FREDERICK COUNTY PLANNING COMMISSION

TITLE: **Remax Urbana**

FILE NUMBER: **SP12-03 AP SP260406**

REQUEST: **Concept Plan Approval**

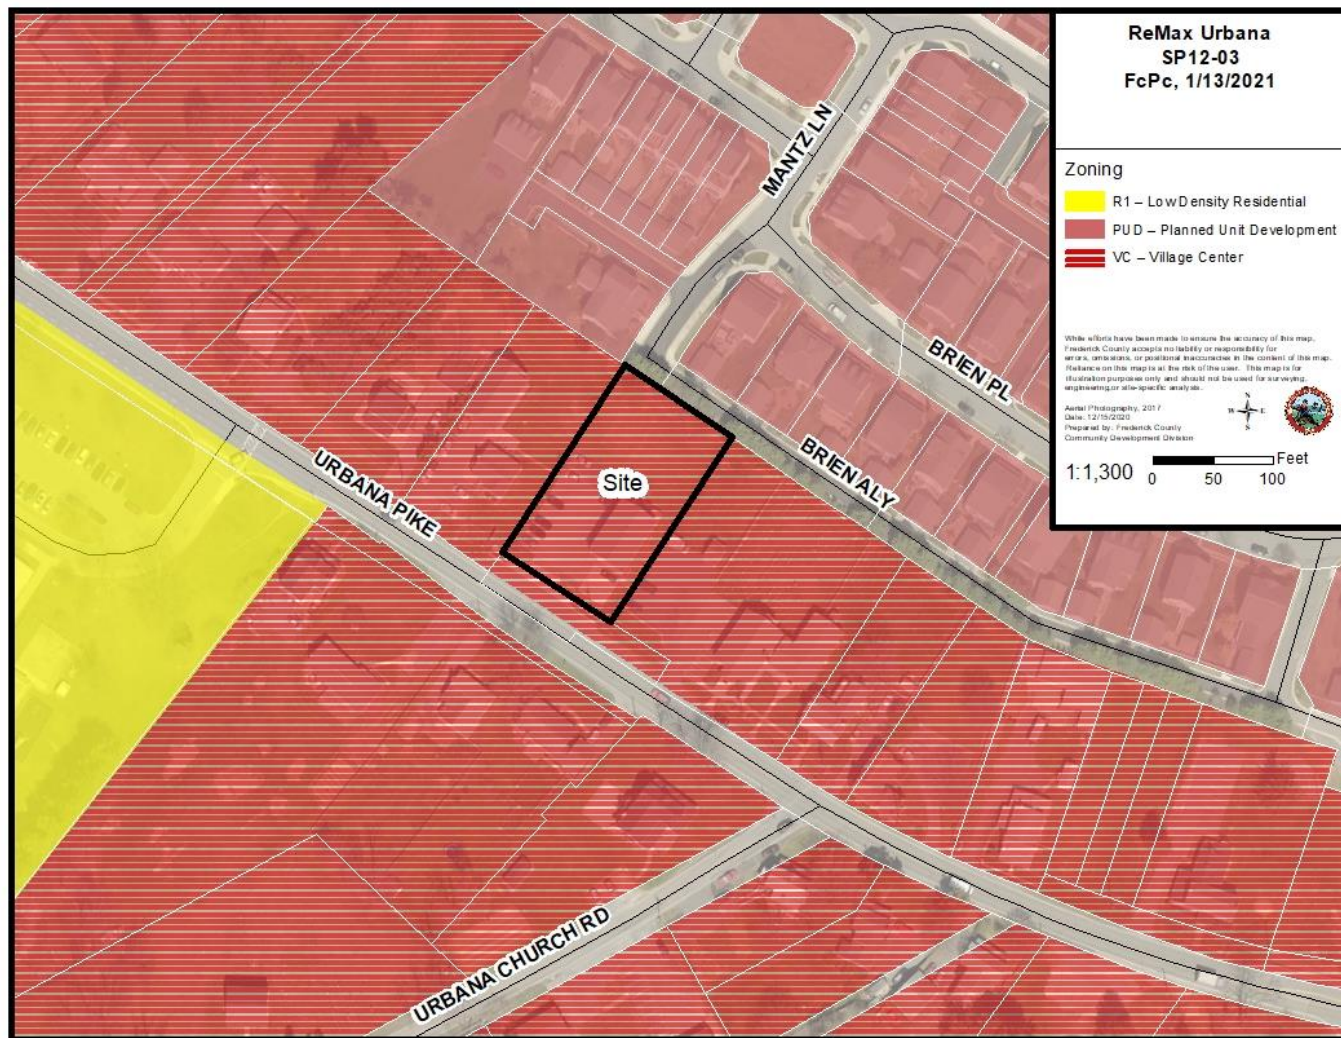
The intent of the application is to expand the existing two-story structure by constructing a 5,180 sq. ft. two story addition (a combined total for both the front and rear additions to the existing building). The result will be a two-story building with a footprint of 4,190 sq. ft. and 8,380 sq. ft. of total professional office space.
